The Sizewell C Project

5.6Ad Sizewell Link Road Flood Risk Assessment Addendum

June 2021

Plate 4.1: Extract from drawing SZC-SZ0204-XX-000-DRW-100137 Rev02 showing Crossing 1 diversion

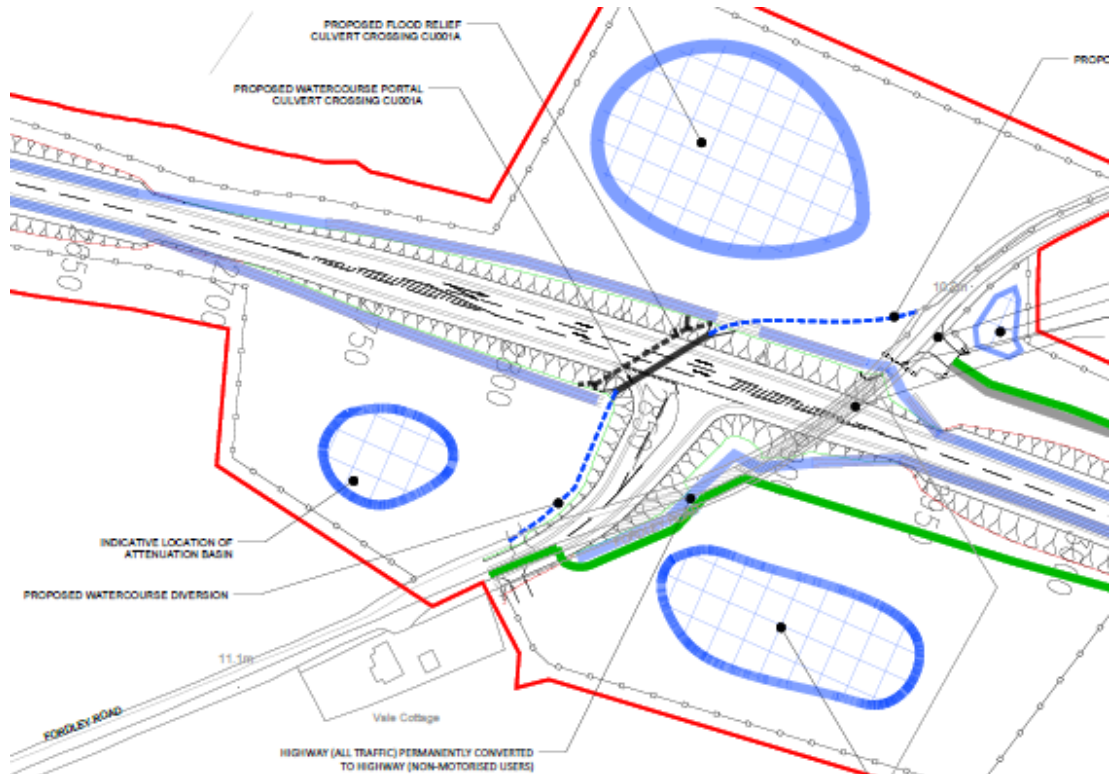
" There are missing elements from the hydraulic model which mean the evidence to support the FRA is lacking in the detail we would expect. It appears as though some aspects of the FRA are based on outline design rather than final designs and some aspects have not been properly considered at all.[...] Flood risk in the baseline and 'with crossing' scenarios has not been mapped so it's very difficult to properly understand third party impacts, particularly where there are out of bank flows such as at SW1 and SW3."

"Report and proposed crossing layouts imply basic portal culverts have been used at all the crossings which is not correct. There has been little evidence that the knowledge of flood risk has informed and evidenced the design of the culverts and associated flood relief structures and mammal ledges."

- 4.2.1 As discussed in **Section 3.2** of this document, the hydraulic models for crossings 1 and 2 were combined into a single model and updated with the surveyed cross-sections.
- 4.2.2 The concept of the proposed design at crossings 1 and 2 has not changed from that presented in the Application, **Appendix A: Sizewell Link Road Modelling Report** [[APP-137](#)]. At crossing 1 (Fordley Road), a diversion of the Main River (Middleton Watercourse) is proposed, as illustrated in **Plate**

4.1. This allows the length of the culverted section through the Sizewell link road to be minimised and also eliminates the requirement for another crossing at the connection between Fordley Road and the Sizewell link road.

Plate 4.19: Plan view of the proposed dual culvert system and overland flow route at crossing 7 (extract from drawing no. SZC-AD0310-WSP-SLRHDG-ZZ0000-DRW-HCD-300003)

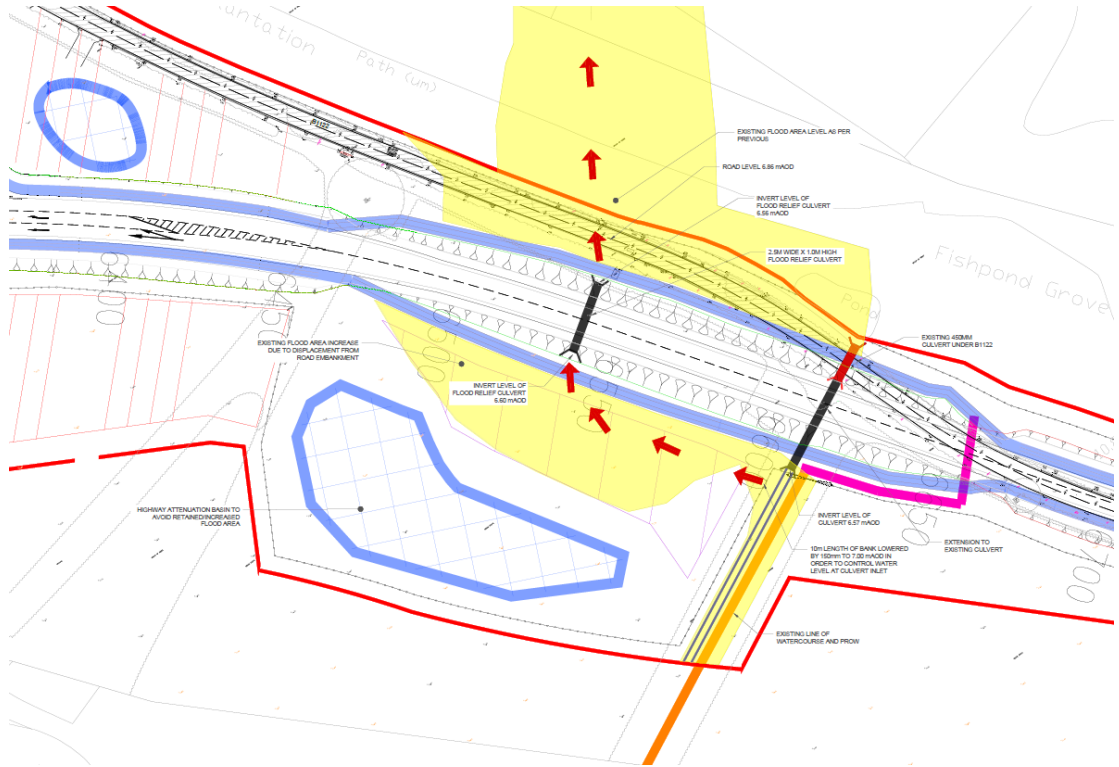
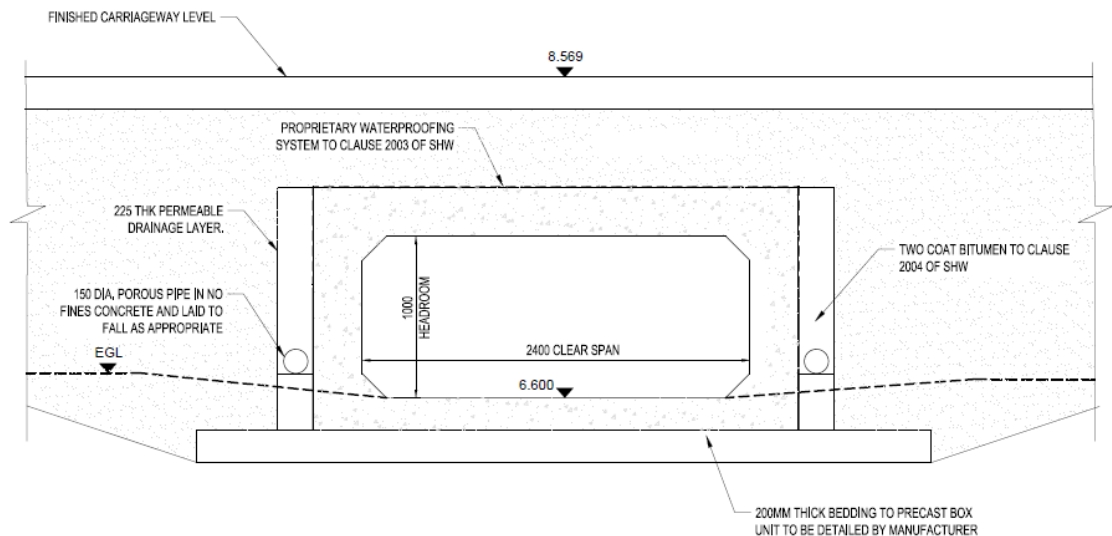
*“No flood risk assessment of proposed crossing at SW7.
FRA does not show the road will be safe for its lifetime
without increasing flood risk elsewhere” [...].*

- 4.6.5 In addition, the surface water flood map (**Figure 3** of the **Sizewell Link Road Flood Risk Assessment** [[APP-138](#)]) shows that during an extreme flood event, water currently ponds in a topographically low-lying area to the left of the channel before then flowing over the B1122. This was confirmed during a site visit following a heavy rainfall event.
